SUBJECT: FINAL RESPONSE TO TASK INTERFACE AGREEMENT 2011-008,
SAN ONOFRE NUCLEAR GENERATING STATION USE OF
AMERICAN CONCRETE INSTITUTE REPORTS FOR EVALUATIONS
RELATED TO STEAM GENERATOR REPLACEMENT CONTAINMENT
RESTORATION

TASK INTERFACE AGREEMENT 2011-008

SAN ONOFRE NUCLEAR GENERATING STATION USE OF AMERICAN CONCRETE

INSTITUTE REPORTS FOR EVALUATIONS RELATED TO STEAM GENERATOR

Figure H.2 – Convergence of Sectional Stiffness between ANSYS and ACI 224: Load Combination III

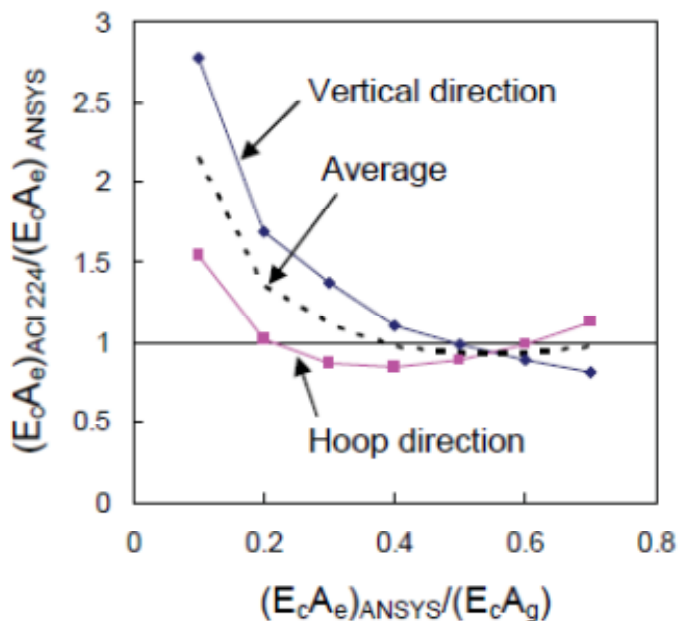
The NRC staff finds that the convergence criteria used in Step 6 of the above described algorithm, based on the average curve, to determine the best-estimate reduced stiffness to be rather arbitrary and not a mathematical convergence of the algorithm used. Further, the criteria does not seek to satisfy nor does the converged solution so-obtained satisfy the simplifying assumption/approximation that the effective (reduced) stiffness in the vertical and hoop directions are equal, that forms the basis of the ANSYS analyses in the parametric study from which the values of strain, ϵ_m , in the vertical and hoop directions are obtained. Therefore, the NRC staff position is that a mathematically converged solution for reduced effective axial stiffness values based on ACI 224.2R should also result in the values of $(E_c A_e)_{ACI\ 224}$ being equal for both hoop and vertical directions and should be a necessary condition in the convergence criteria.

Considering the data and assumptions in Figure H.2 of Reference 4, the NRC staff observes that the rational mathematical convergence criteria to be used to determine the converged value (best-estimate) of reduced effective axial stiffness between ANSYS parametric study and ACI 224.2R-estimated values should be the value of $(E_c A_e)_{ANSYS}$ for which:

$$[(E_c A_e)_{ACI\ 224} / (E_c A_e)_{ANSYS}]_{Hoop} = [(E_c A_e)_{ACI\ 224} / (E_c A_e)_{ANSYS}]_{Vertical} = 1 (\pm 10\%)$$

This criterion mathematically satisfies the converged ACI 224.2R-based solution and the assumption in the ANSYS parametric analysis in that the effective stiffnesses in the two directions are equal. The NRC staff recognizes that these ratios for the two directions are not expected to converge exactly to 1 because of the simplifying assumptions and approximations in the 1-dimensional ACI 224.2R method relative to the 3-dimensional ANSYS parametric analyses, but would be approximately close to 1 (± 10 percent commonly accepted) if the ACI 224.2R model is appropriate for the application. If not, the ACI 224.2R-based equations are not appropriate to model reduced axial stiffness of concrete due to cracking in a complex 3-dimensional structure. Using the above criterion with reference to Figure H.2 on page 84 of Reference 4 (also reproduced on previous page), the staff observes that the converged value (best-estimate) of reduced effective axial stiffness for LC III would be the value corresponding to the intersection of the vertical and hoop curves.

The NRR staff agrees and accepts the $0.4E_cA_g$ value used by the licensee as a lower-bound value of effective stiffness that maximizes the redistribution of forces due to cracking to the surrounding area and would be the conservative or controlling case for design evaluation of the areas surrounding the opening. However, the NRC staff observes that the controlling case for design evaluation of the SGR opening area itself would be based on an upper-bound value of effective stiffness in the opening area that would minimize the redistribution of forces due to cracking providing upper-bound design forces for the opening area under the critical load combinations. The NRC staff independently evaluated the safety-significance of the two quality-related observations in the next paragraph and did not identify a safety concern. However, the NRC staff recommends that a design evaluation based on reasonable upper-bound value from the best-estimate (factoring the staff observation on convergence criteria) of effective cracking stiffness for the SGR opening area also be addressed in order to demonstrate that upper-bound design forces and moments in the SGR opening area itself meets the acceptance criteria described in Section 3.8.1 and Table 3.8-1 of the UFSAR.
